PLANNING APPROVAL STAFF REPORT**Date: October 4, 2007**

NAME Mobile Area Water & Sewer System (Volkert & Associates, Inc., Agents)

CONTEMPLATED USE Planning Approval to allow a wastewater pumping station in an R-1, Single-Family Residential District.

SITE PLAN

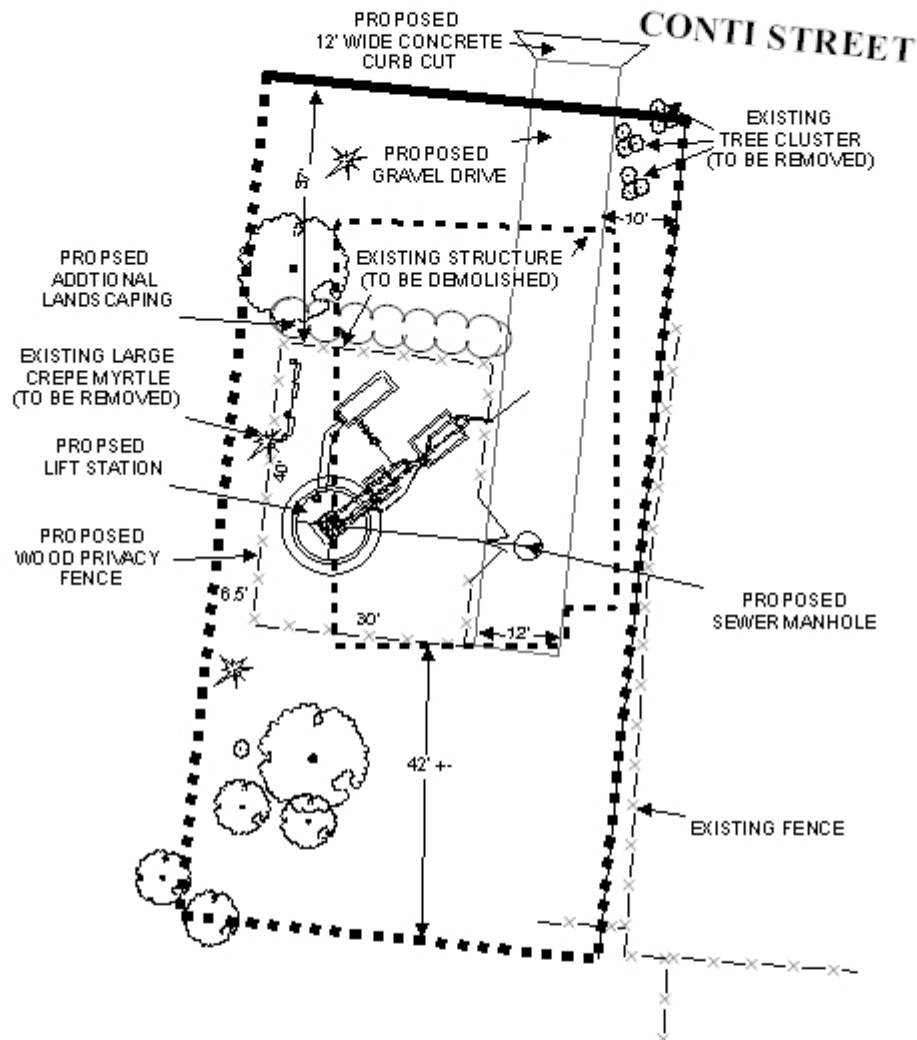
As proposed, the access drive would be gravel, and the COA for the pumping station construction specifically states "A gravel drive will be installed on the eastern portion of the lot that will blend with the residential character of the adjacent properties". Inasmuch as the intent of the gravel drive is to be harmonious with the residential character of the neighborhood, this is to be a commercial/industrial use. The Zoning Ordinance requires that the drive be constructed of asphalt, concrete, or an approved alternative paving surface, or a paving surface variance must be approved by the Board of Zoning Adjustment for the gravel drive. Also, a vehicular parking and turn-around area should be provided to eliminate back-out traffic into Conti Street.

The site plan indicates that the pumping equipment is to be enclosed within a 6' high wooden privacy fence compound internal to the site, and the COA specifies that the station will not exceed the height of the fence. This should be made a requirement of the Planning Approval review, also. However, no elevation drawings were furnished with the application to indicate equipment height. Since the site is to be used in a commercial/industrial manner and is located within residential zoning and use, the Zoning Ordinance requires that the site be buffered from adjacent residential properties by a protection buffer strip not less than 10' in width. As proposed, the compound around the pumping equipment is to be 6.5' off the West property line;

therefore, the site plan should be revised to ensure that the compound is no closer than 10' from any adjacent residentially-used property. Also, the provision of a 6' high wooden privacy fence along the East, West, and South property lines where the site adjoins residential use should be required. Any revisions to the site plan beyond what the ARB originally approved would require further ARB approvals.

The site plan does not depict compliance with the tree and landscaping requirements of the Zoning Ordinance, however, full compliance will be required.

- 1) submission of information regarding the anticipated times of use of the facility and associated noise levels;
- 2) revision of the site plan to indicate that the access drive will be asphalt, gravel, or an approved alternative surface, or submission of a letter of understanding that a surface variance request to the Board of Zoning Adjustment will be required;

- 3) revision of the site plan to include a vehicle parking and turn-around area to eliminate back-out traffic into Conti Street;
- 4) submission of pumping equipment elevation drawings to ensure that a 6' high compound is adequate for visual and noise screening;

- 5) revision of the site plan to ensure that the internal compound around the pumping equipment is at least 10' from the East, West, and South property lines;

- 6) revision of the site plan to depict a 6' high wooden privacy fence along the East, West, and South property lines;
- 7) revision of the site plan to indicate compliance with the landscaping and tree planting requirements of the Zoning Ordinance; and
